Assumption Change Control Sheet

Test	5a – 5b, DHW response time
Assumption	38. Minimum keep-warm cycle duration

Change Originator	Tom Naughton
Change Request No.	025
Date of Request	27/08/2020
Proposed Change to Assumption?	Yes

Vital Energi keep warm test (4a – 70C primary flow temperature)

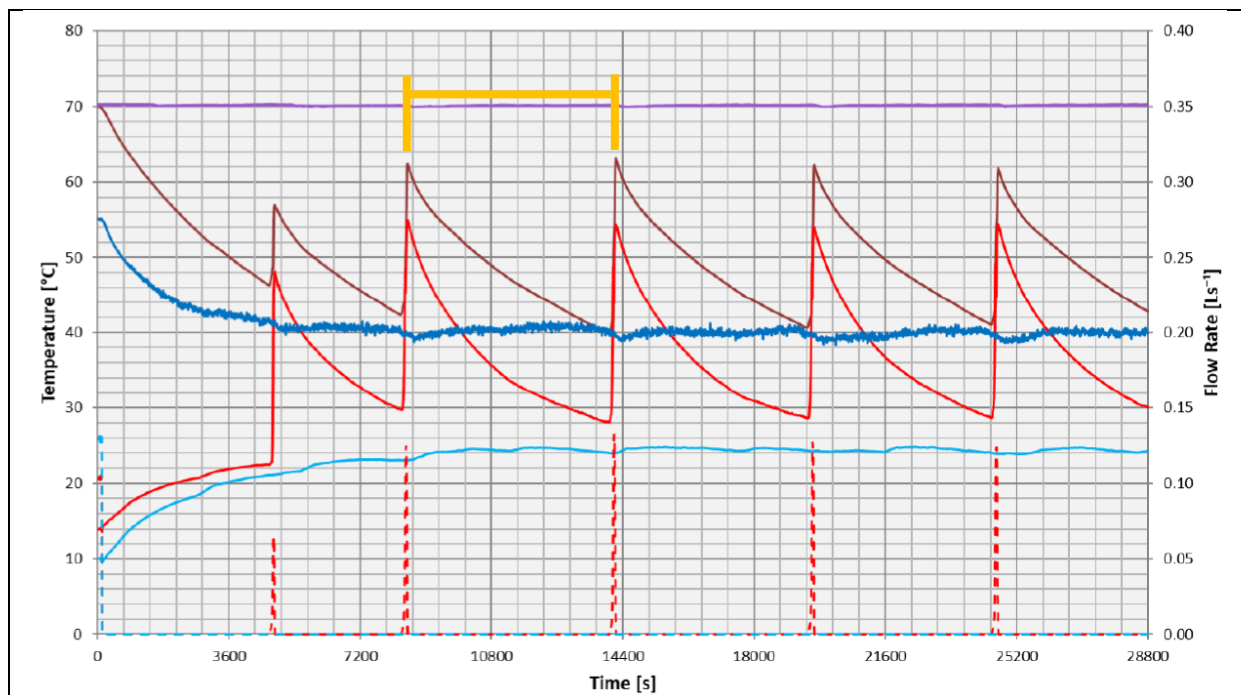
From evaluating the current HIUs tested, the significant majority have keep warm cycles that are less than 15 minutes. Only three HIUs (Vital, Nexus and YGHP) have keep warm cycles greater than 15 minutes.

HIU	70C keep warm cycle time (min)	60C keep warm cycle time (min)
Vital	30	30
Nexus	15	15
YGHP	90	45

It is considered that 2 hours (120 minutes) is the maximum cycle time that can be considered to satisfy both purposes of the test.

It is proposed that the maximum period between any single keep-warm cycle is reduced to 2 hours.
